Attachment A4

**Urban Design Report – Bates Smart – 15-25
Hunter and 105-107 Pitt Street, Sydney -
Part 3**

Design Advisory Panel Feedback

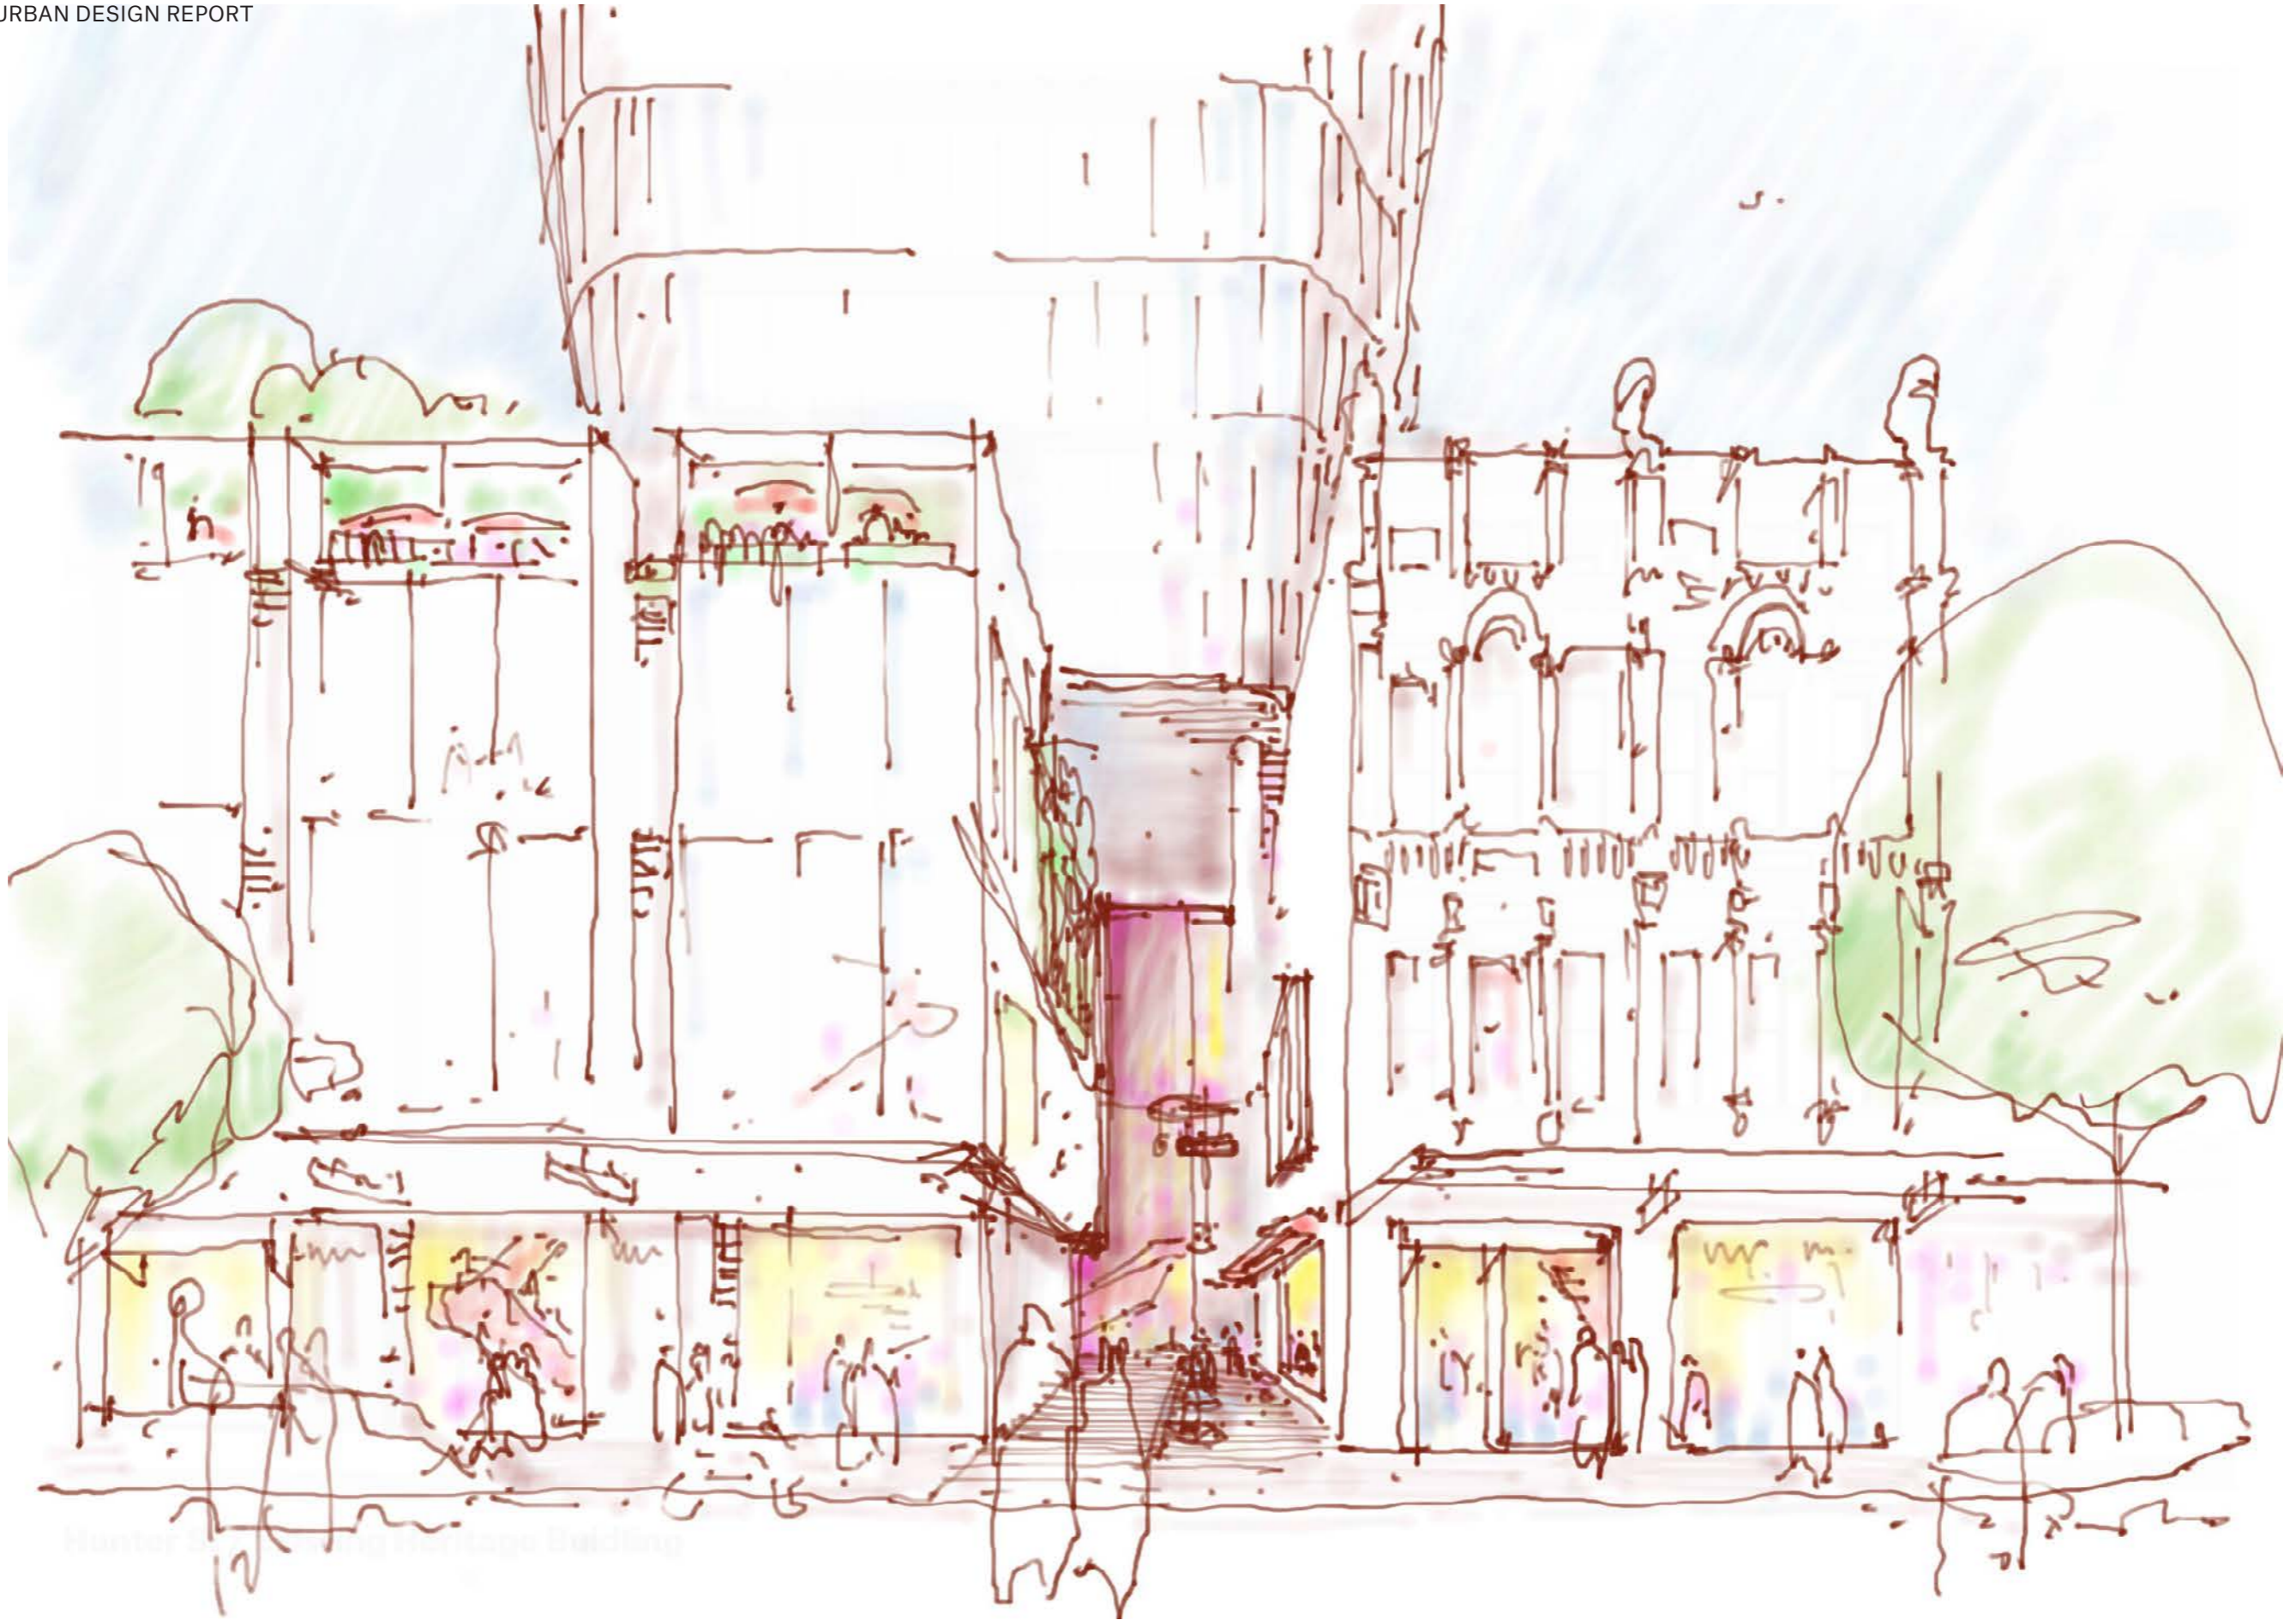
DAP recommended that refinement of the building envelope should provide the previously recommended 15% articulation provision.

The requested articulation level has been adopted.
